APPLICATION NUMBER: 25/0425
PROPOSAL: DEMOLITION OF THE EXISTING GARAGE AND ERECTION OF TWO-STOREY EXTENSION AT THE REAR TOGETHER WITH THE CHANGE OF USE THE FORMER FUNERAL DIRECTORS (A1) TO FACILITATE THE CREATION OF NO.5 FLATS FOR SPECIALISED SUPPORTED HOUSING WITH OVERNIGHT ACCOMMODATION FOR CARE PROVIDER
SITE: 140 Caerleon Road, Newport NP19 7GS
APPLICATION TYPE: Full

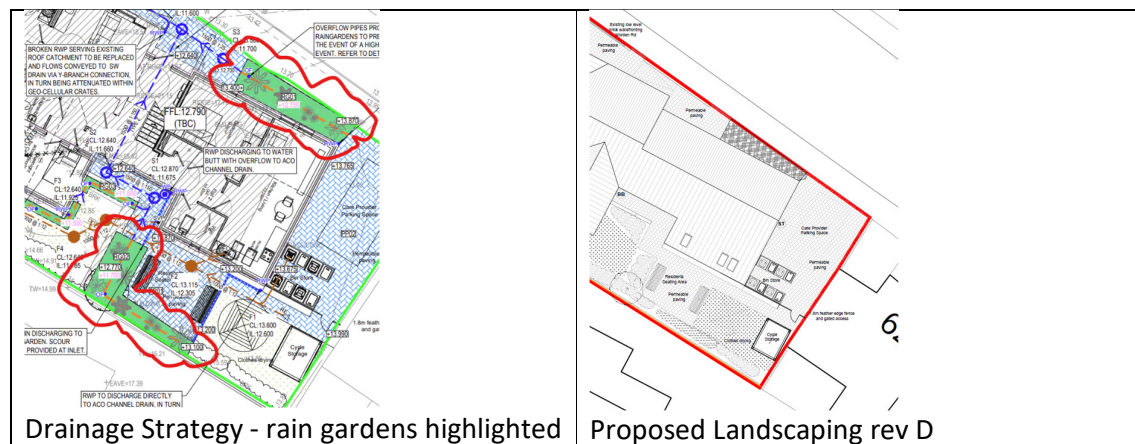
Planting needs to reflect 'right plant right place', in addition the submitted drainage strategy below shows two rain gardens which are not acknowledged on the submitted Proposed Landscaping plan, and plant species should be able to cope with a range of dry and wet conditions.

Also to note the rain garden to the north will be in full shade from building and fence line; rain garden to the south may be in shade from the fence line.
